Service Bulletin

4 - STROKE
GS/GSX/GSX-R BULLETIN NO. 183
DATE: 6/6/2008

**SAFETY RECALL CAMPAIGN #2A05
CERTAIN 2008 GSX1300RK8 MOTORCYCLES
IGNITION SWITCH INSPECTION/REPLACEMENT**

SUBJECT: RECALL CAMPAIGN - IGNITION SWITCH INSPECTION/
REPLACEMENT

INSPECT ROUTING

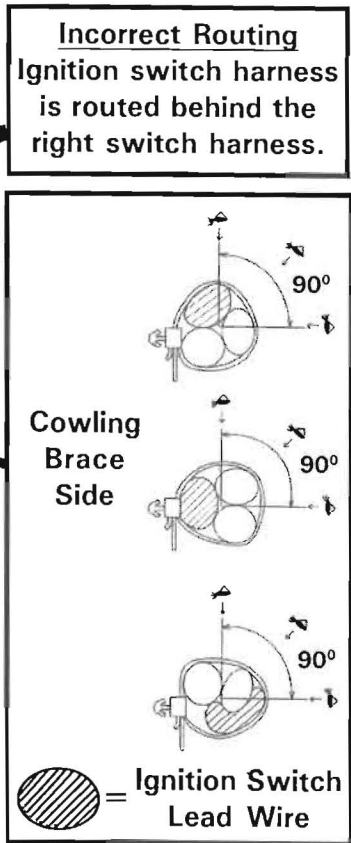
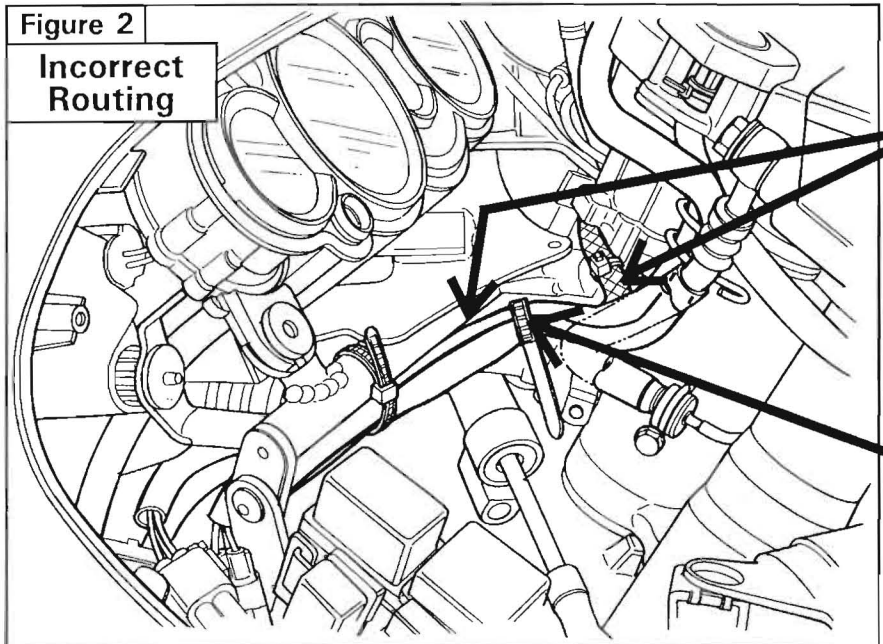
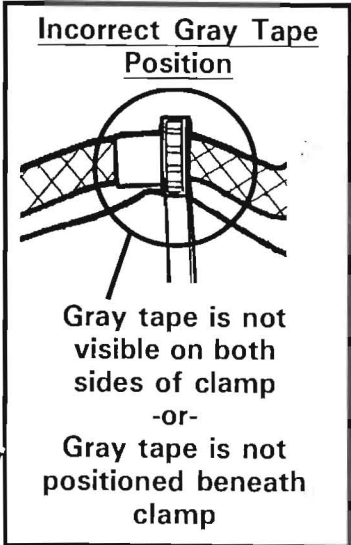
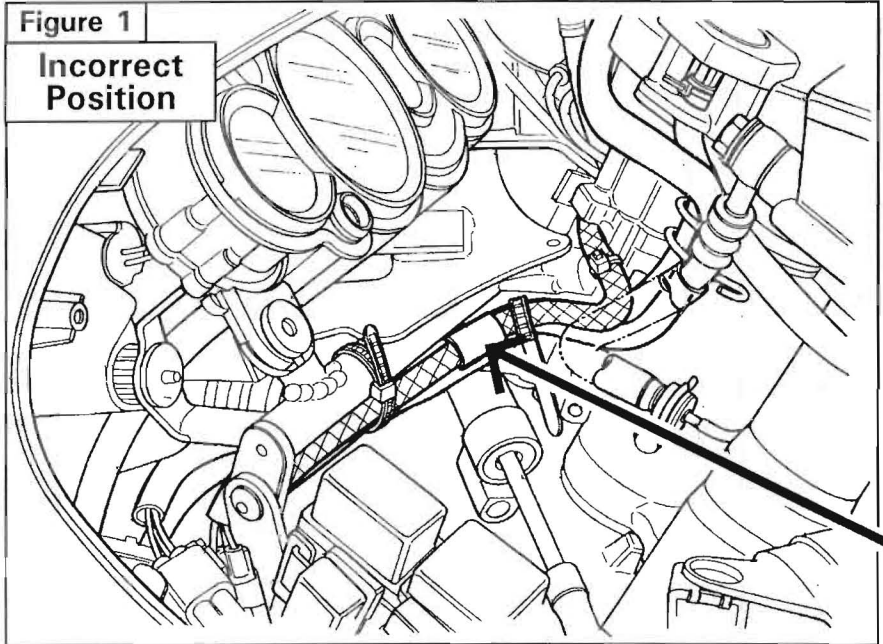
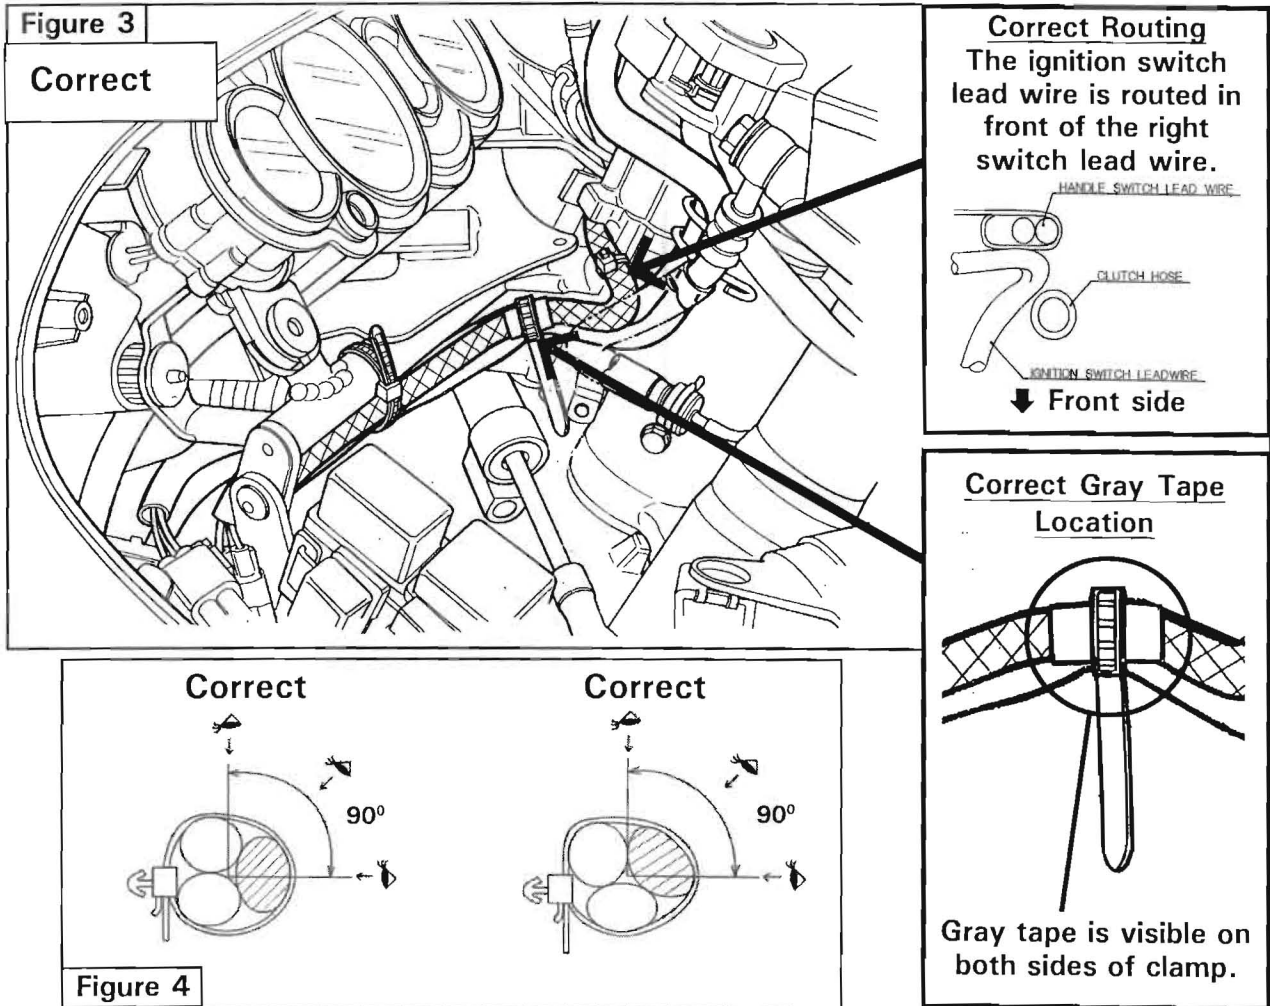
Suzuki Motor Corporation has determined that certain GSX1300RK8 motorcycles may have the ignition switch lead wire improperly routed. Handlebar movement can result in abnormal flexing and damage to the ignition switch lead wire. Damage to the ignition switch lead wire can result in intermittent or complete loss of electrical power, which can result in loss of lighting and/or stalling of the engine. This could result in a crash.

1. Remove the upper and lower meter panels (refer to Service Manual page 9D-15).
2. Check if the ignition switch lead wire is clamped and routed correctly. Incorrect positions are shown in Figures 1 and 2. Correct routing and clamping is shown in Figures 3 and 4 on page 5.

1. Reroute the ignition switch lead wire correctly (Figure 3 and Figure 4). The ignition switch lead wire should not be covered by the other wire harnesses.
2. Turn the handlebars back and forth to verify that the steering operates smoothly and the wiring harness does not become kinked or pinched.
3. Proceed to PUNCH MARK AT VIN on page 8.

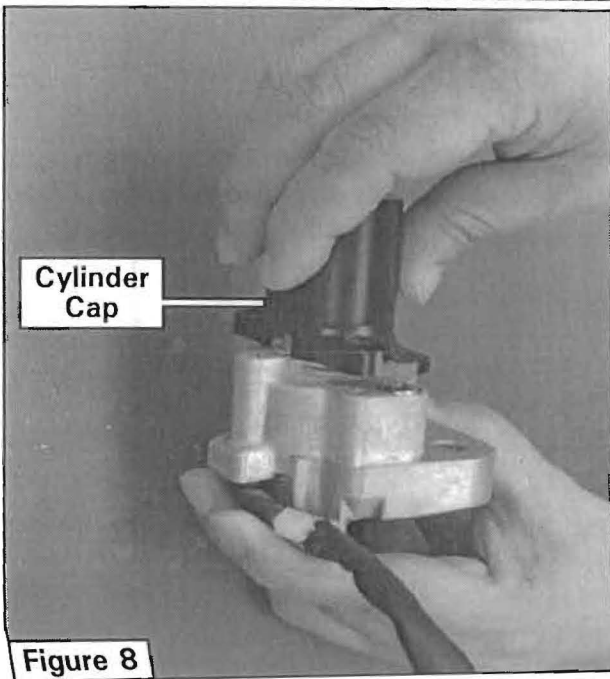
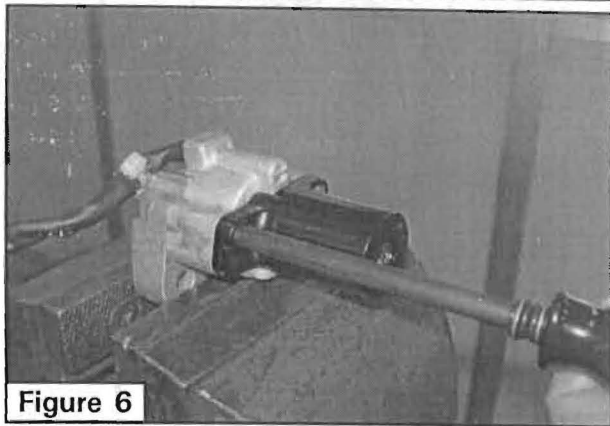
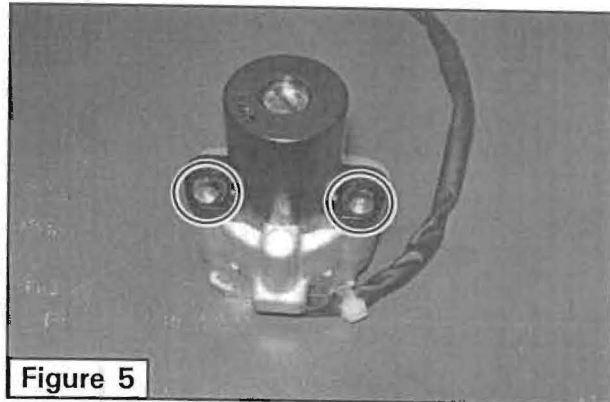
1. Remove the ignition switch assembly from the motorcycle (refer to Service Manual page 1H-12).
2. Remove the two black plastic covers to access the cylinder cap mounting bolts (Figure 5).
Note: The black plastic covers will not be reused.
3. Secure the mount area (bottom) of the ignition switch in a vise (Figure 6).

TOOL Remove the two "break-off" screws from the ignition switch using the special screwdriver. Set the stepped end of the sleeve on the special screwdriver facing toward the "break-off" screws (Figure 7). Strike the special screwdriver 5 to 7 times with a hammer to produce a deep enough groove on the screw head for the screwdriver to work properly (Figure 6). Pay attention not to hit other parts with the hammer. Turn to remove the "break-off" screws in a counter-clockwise direction. If the groove becomes damaged, make another groove at a 90° angle to the original groove.

4. Remove the ignition switch from the vise and hold it upright over the workbench and carefully remove the cylinder cap (Figure 8).

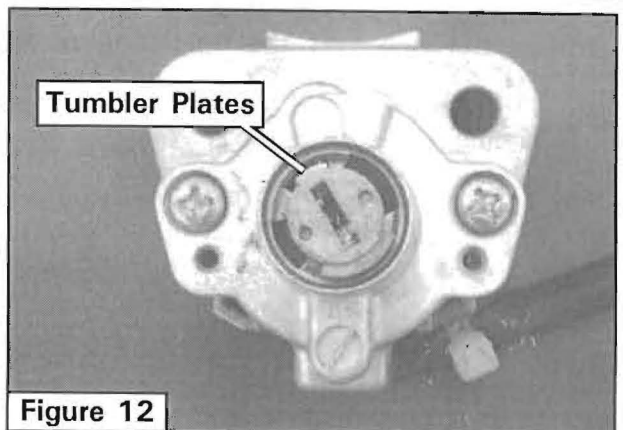
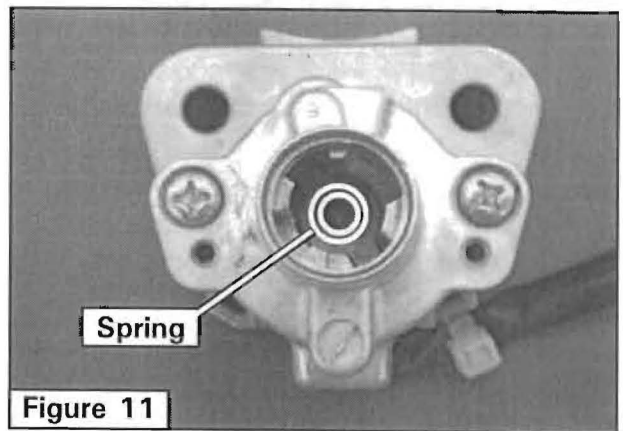
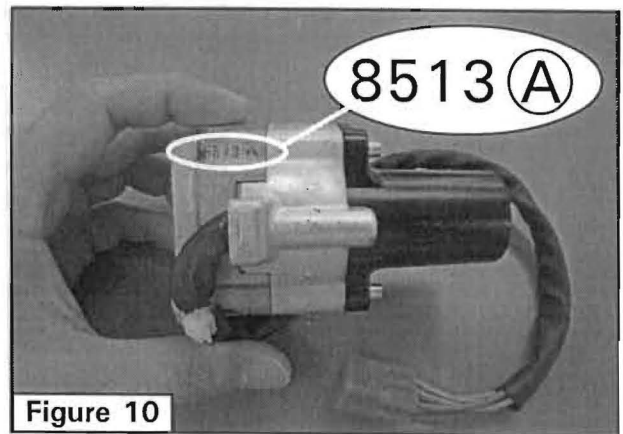
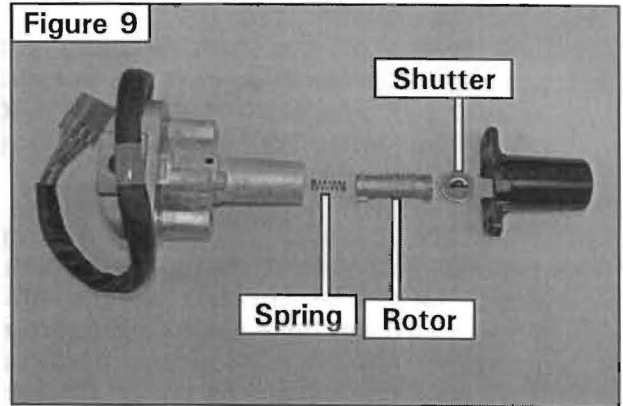
Begin reassembly using the main body of the new ignition switch. The new (recall kit) ignition switch body can be identified by the letter "A" at the end of the lot number (Figure 10).

- Set the spring from the original ignition switch onto the projection in the new ignition switch body (Figure 11).

- Install the rotor from the original ignition switch into the new ignition switch body. There is only one correct position (Figure 12) to install the rotor into the ignition switch body. Note the position of the tumbler plates when the rotor is installed. When installed in the correct position, the rotor will drop into the new ignition switch body smoothly and easily. Do not force or push the rotor into the ignition switch or damage may occur.

Figure 13

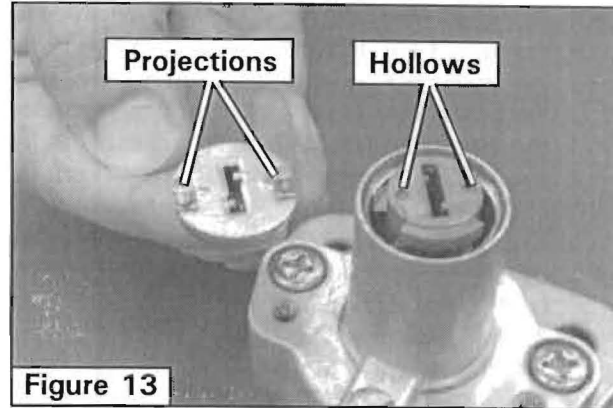
10. Place the shutter from the original ignition switch on the rotor, aligning and placing the projections into the hollows (Figure 13). The shutter can be aligned one of two ways 180° apart. Either way is correct.

12. Secure the cylinder cap with the break-off screws. Tighten the screws evenly until the screw heads break off (Figure 14). Install the plastic caps (provided in the kit) on the cylinder cap over the break-off screws.
